Access Compliance Report

Public Rights-of-Way

Intersection ID: 29425	Main Street: BRADSTREET_COMMONS_WY	Cross Street: NOVELLA_DR	Location: NW
ADA ID: B8460F8DFFB0	Ramp Type: Perp	Initial Pass/Fail: Fail	Overall Compliance: No
Severity Score: 46.25			
Codes/Mitigation Info/Possible Solution		Field Measurements/Component Compliance

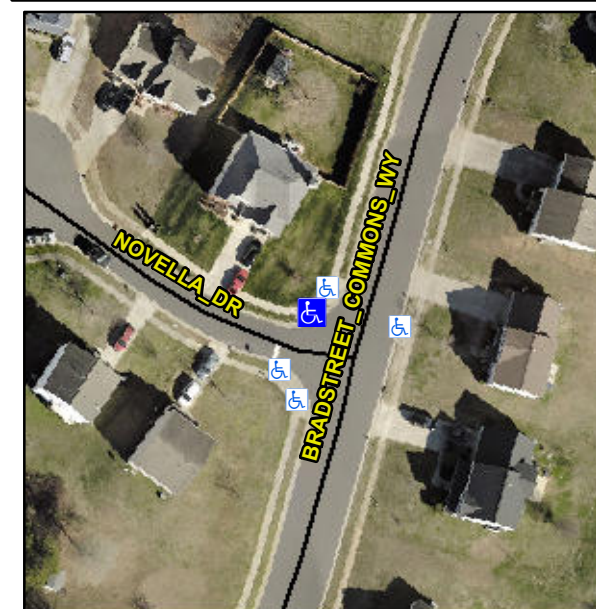
Not Found, R304.5.1, R304.2.2, R304.5.3

Compliance	Description	Data	Compliance	Description	Data
N/A	Ramp Length (in)	49.0	No	Ramp Slope (%)	9.3
No	Ramp Width (in)	47.0	No	Ramp XSlope (%)	9.2
N/A	Flare Type LT	N/A	N/A	Flare Type RT	N/A
N/A	Flare Slope LT (%)	N/A	N/A	Flare Slope RT (%)	N/A
N/A	Flare Traversable LT?	N/A	N/A	Flare Traversable RT?	N/A
N/A	Landing Length (in)	N/A	N/A	DWS Provided?	N/A
N/A	Landing Width (in)	N/A	N/A	DWS Contrast?	N/A
N/A	Landing Slope (%)	N/A	N/A	DWS Length (in)	N/A
N/A	Landing X Slope (%)	N/A	N/A	DWS Full Width?	N/A
N/A	Landing Curb? (Y/N)	N/A	N/A	DWS Offset (in)	N/A
N/A	Shared Landing?	N/A			
N/A	Gutter Ponding?	N/A	N/A	Gutter Slope (%)	N/A
N/A	Gutter Lip Ht (in)	N/A	N/A	Gutter X Slope (%)	N/A
N/A	Painted X Walk1?	No	N/A	Painted X Walk2?	N/A
	X Walk 1 Direction	To S		X Walk 2 Direction	N/A
N/A	X Walk 1 Width (in)	N/A	N/A	X Walk 2 Width (in)	N/A
	X Walk 1 Slope (%)	0.3		X Walk 2 Slope (%)	N/A
	X Walk 1 X Slope (%)	7.1		X Walk 2 X Slope (%)	N/A

Remove & Replace Entire Ramp.
